E4411B-08

S E R V I C E N O T E

E4411B 1.5 GHz Spectrum Analyzer

Firmware Update to Fix High Noise Floor on the Analyzer Screen.

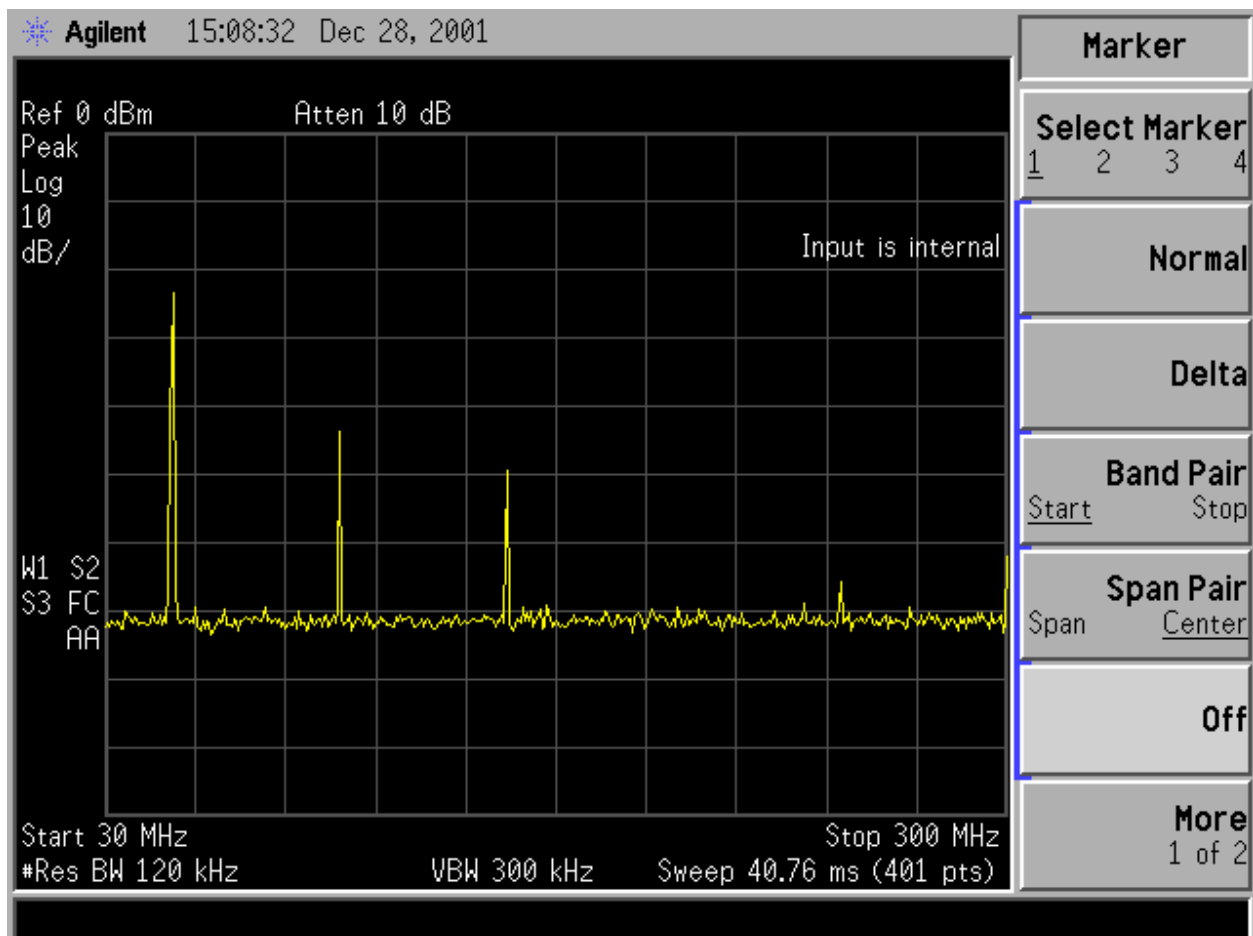
Press Preset, Frequency ->Start Freq 30 MHz, Stop Freq 300 MHz, BW/Avg. ->Resolution BW 120 kHz, Input ->Amptd. Ref ON.

You should see the Alignment signal (50 MHz) and harmonics on screen as shown below.

Press System, More 1 of 3, More 2 of 3, Service –2010 Enter, Service, Align, LO. If the instrument is affected, then either the Align signal & harmonics will disappear or they will move around quickly and erratically on screen. If this occurs, contact the customer and verify the latest shipping version of ESA firmware can be upgraded in their instrument. If the instrument has option B72, Expanded Memory the instrument can be upgraded to the latest and greatest firmware. Otherwise, A.07.05 is the
